ECE/TRANS/WP.29/2009/22  
17 December 2008

Proposal for Supplement 3 to the 04 series of amendments to Regulation No. 48  
(Installation of lighting and light-signalling devices)

Submitted by the Working Party on Lighting and Light-Signalling (GRE) \*/

FIGURE (see paragraph 6. 5.)

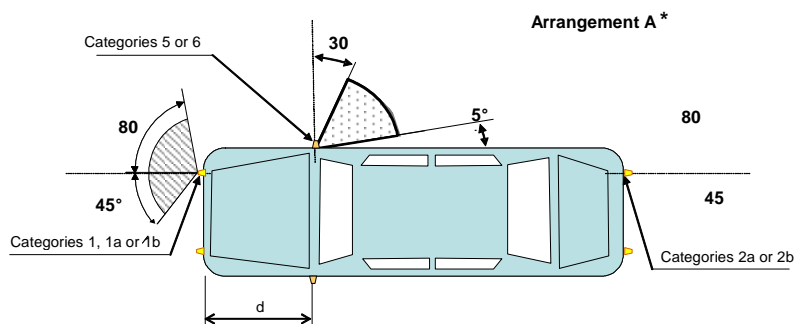
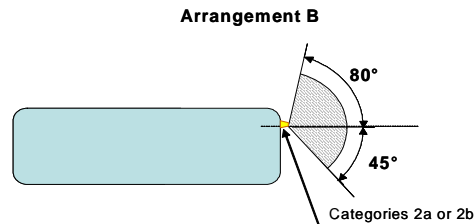
Paragraph 6.5.5.1., amend to read:

"6.5.5.1. Horizontal angles, (see figure below)

Vertical angles: 15° above and below the horizontal for direction-indicator lamps of categories 1, 1a, 1b, 2a, 2b and 5. The vertical angle below the horizontal may be reduced to 5° if the lamps are less than 750 mm above the ground; 30° above and 5° below the horizontal for direction-indicator lamps of category 6. The vertical angle above the horizontal may be reduced to 5° if the optional lamps are not less than 2,100 mm above the ground.

For M1 and N1 category vehicles, the value of 45° inward for the direction indicator lamps of categories 1, 1a or 1b, whose lower edge of the apparent surface is less than 750 mm above the ground, may be reduced to 20° under the horizontal plane containing the reference axis of this lamp.

(\*) The value of 5° given for dead angle of visibility to the rear of the side-direction indicator is an upper limit.  $d \leq 1.80$  m( for M<sub>1</sub> and N<sub>1</sub> category vehicles  $d \leq 2.50$  m)."

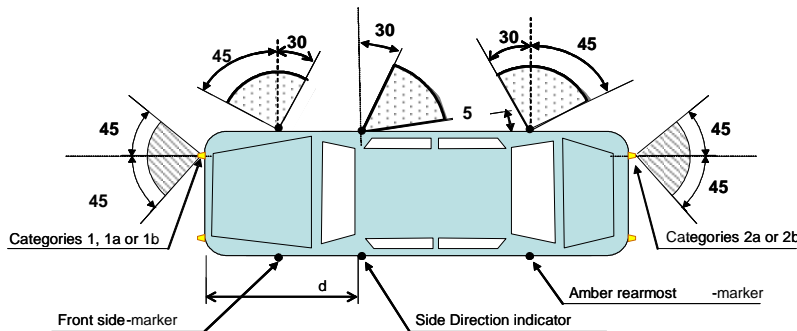
Paragraph 6.5.5.2., amend to read:

"6.5.5.2. or, at the discretion of the manufacturer, for M<sub>1</sub> and N<sub>1</sub> category vehicles (\*\*):

Front and rear direction-indicator lamps, as well as side-marker lamps

Horizontal angles see figure below:

The value of 45° inward for the direction indicator lamps of categories 1, 1a or 1b, whose lower edge of the apparent surface is less than 750 mm above the ground, may be reduced to 20° under the horizontal plane containing the reference axis of this lamp.

(\*\*) The value of 5° given for dead angle of visibility to the rear of the side-direction indicator is an upper limit.  $d \leq 2.50$  m."
